SUBJECT

The Wizard System wiring diagrams for use with Solenoid style locking devices on sliding doors

September 11, 2001

Figure 1: Sliding Door Lock With Wizards (AC ONLY)

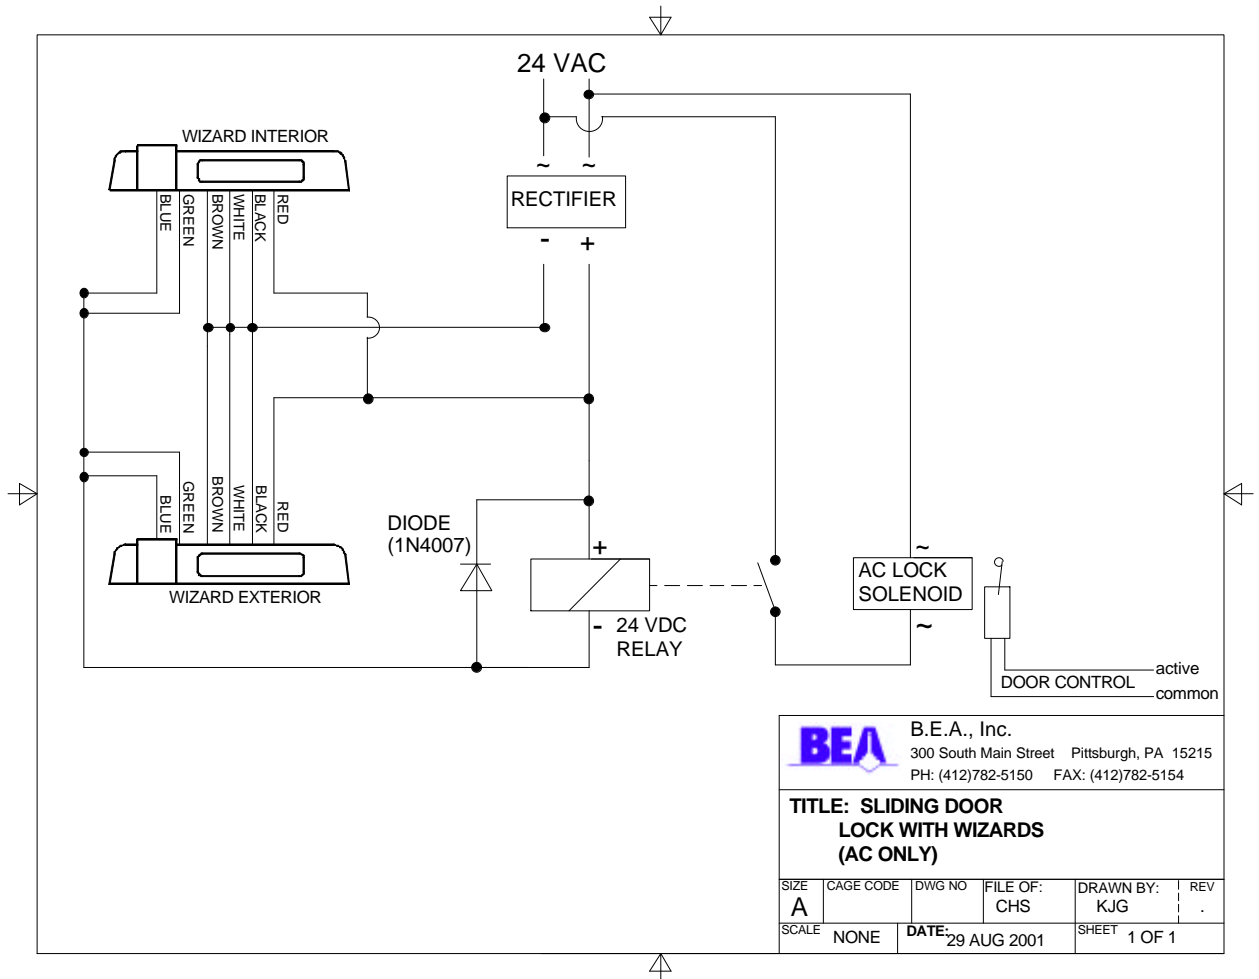
When used with a solenoid-style locking device, we have found that the relay contacts used with the Wizard motion detectors are intermittently failing. A strong arcing from the coil of the solenoid when the signal is dropped is causing this problem.

The locking devices in question are the solenoid-type with microswitch contacts. The plunger of the solenoid pushes against the microswitch tongue when the solenoid receives power. The microswitch contacts then short activation and common of the control box. When wiring a Wizard system into sliding automatic doors with this device please use the following diagrams. Please note the differences in the solenoid locking device with and without a built-in rectifier.
